City of Phoenix PLANNING & DEVELOPMENT DEPARTMENT

Staff Report: Z-39-20-7 November 6, 2020

Estrella [Village Planning Committee](#) Meeting Date November 17, 2020
[Planning Commission](#) Hearing Date December 3, 2020
Request From: [S-1](#) (Approved [C-2 SP](#)) (4.23 acres)
Request To: [CP/GCP](#) (4.23 acres)
Proposed Use Commerce Park uses
Location Approximately 280 feet south of the southwest corner of 91st Avenue and the Durango Street alignment
Owner Durango Farms, LLC
Applicant/Representative Jack Gilmore, Gilmore Planning & Landscape Architecture
Staff Recommendation Approval, subject to stipulations

Figure C. (Above) Site Plan, Source: Gilmore Planning & Landscape Architecture with Planning and Development Department annotations.

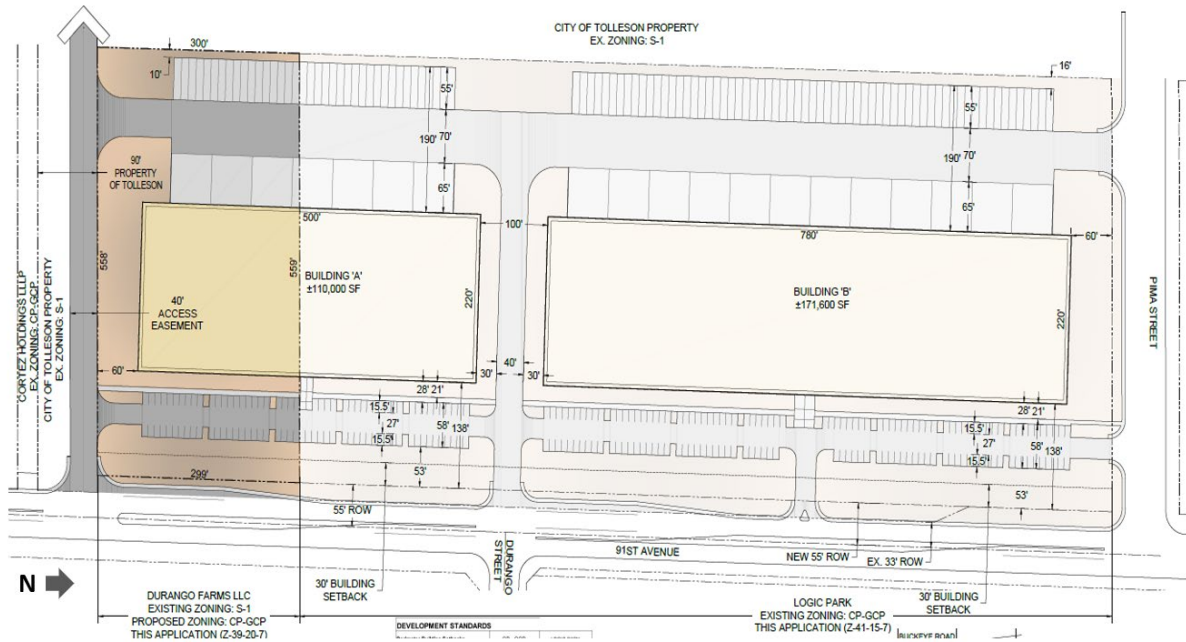
Staff is not recommending a stipulation of require general conformance to the conceptual site plan to avoid potential utility conflicts due to relocation of existing utilities along the 91st Avenue right-of-way.

Stipulation Nos. 1 and 2 would require a minimum building and landscape setback of 50 feet along 91st Avenue in order to allow for an increased separation from the existing homes across 91st Avenue and to remain consistent with the stipulations of rezoning case No. Z-41-15-7 just to the north of the site.

5. The conceptual site plan, shows the location of several landscaped portions on the site, including the landscape setbacks along the south, east and west. Stipulation Nos. 2 and 3 incorporates an enhanced landscape setback along 91st Avenue frontage to provide enhanced screening and buffering from the proposed use and residential uses along the east.

1. A minimum 50-foot building setback shall be provided along the east property line.
2. A minimum 50-foot landscape setback shall be provided along the east property line.
